Accurate Plating/Clearwater Top, Inc. 1937 Calumet Street, Clearwater, Pinellas County, Florida

Response to Department's February 22, 2001 letter, dated November 9, 2001, received November 16, 2001 Contamination Assessment Report, dated and received December 18, 2000, Accurate Plating/Clearwater Top, Inc. 1937 Calumet Street, Clearwater, Pinellas County, Florida

The Florida Department of Environmental Protection (the Department) has reviewed the above referenced response and offers the following comments:

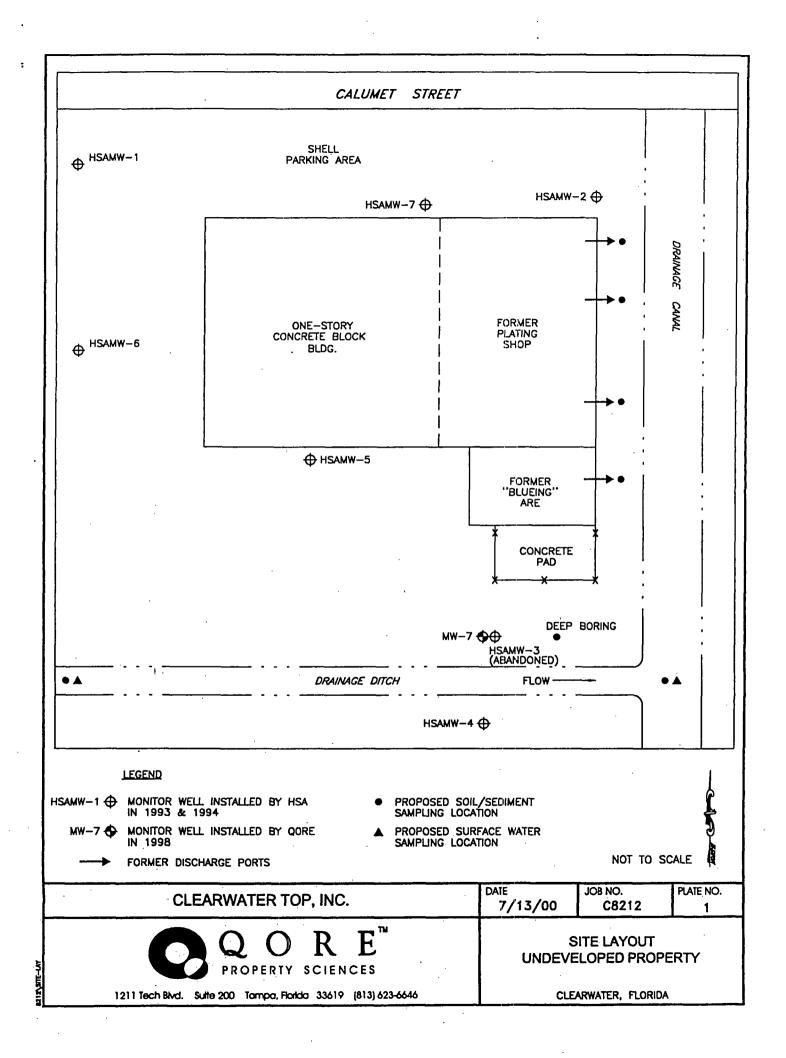
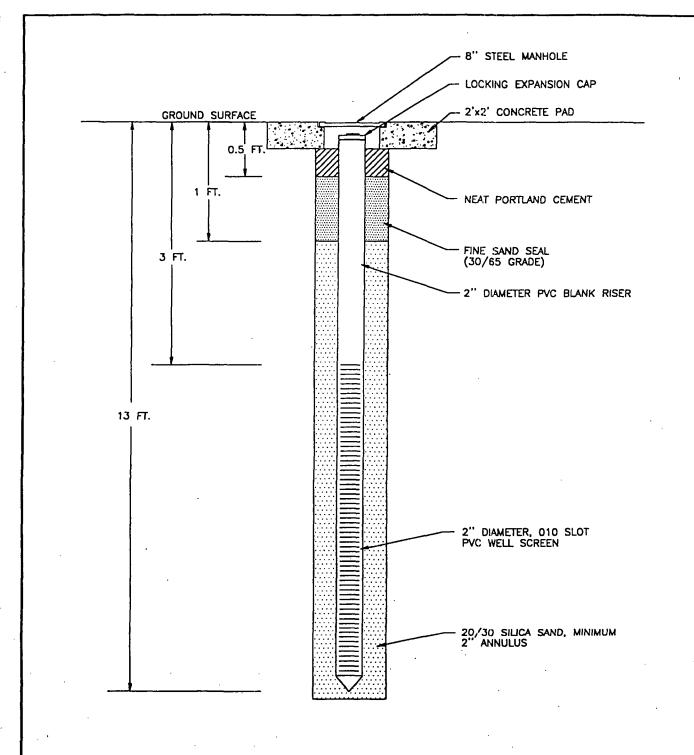
79. The location of HSAMW-3, with a note abandoned, should be located on Figure 1, site layout. The property boundary should be clearly indicated on the site layout.

A revised site layout map, Plate 1, is attached.
